CAYMAN SECTION 4 PHASE 2

**SUBMITTED TO DRAINAGE
BOARD SEPTEMBER 1, 2015**

Cayman Section 4 Phase 2-FINAL DRAINAGE PLAN

FIGURE 8
SHEET 3 OF 3

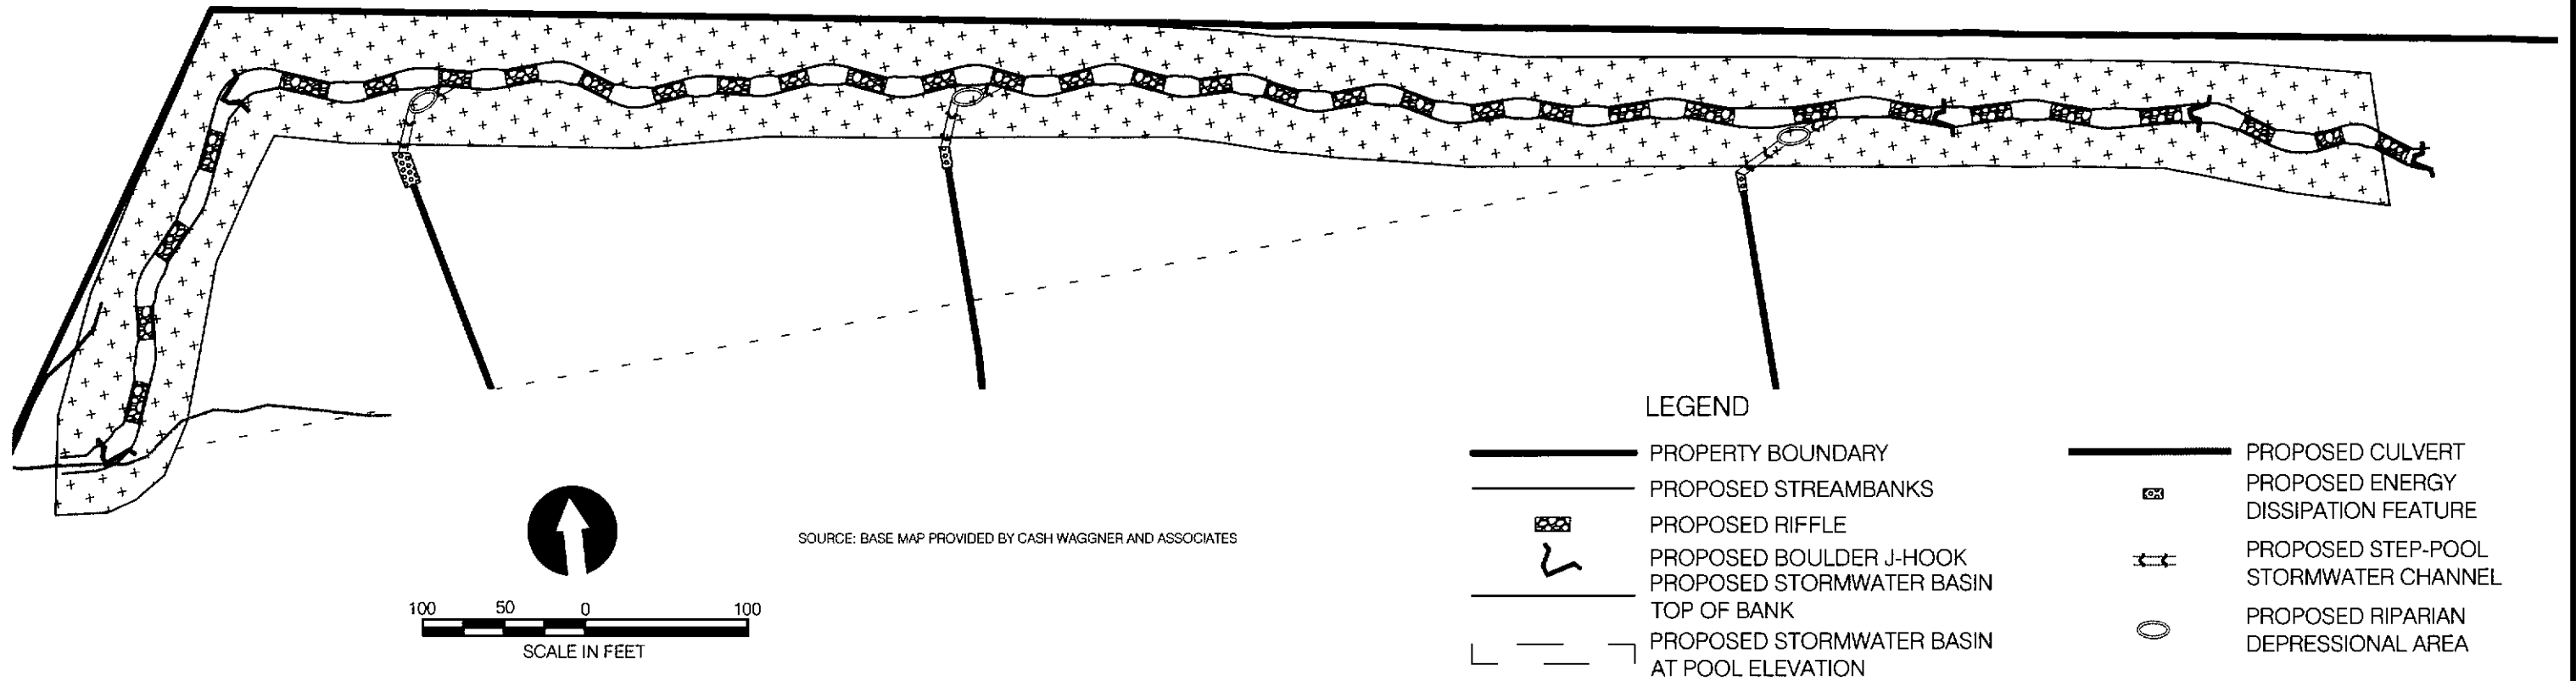
What is the design criteria for the relocated channel as submitted to USCOE? Provided
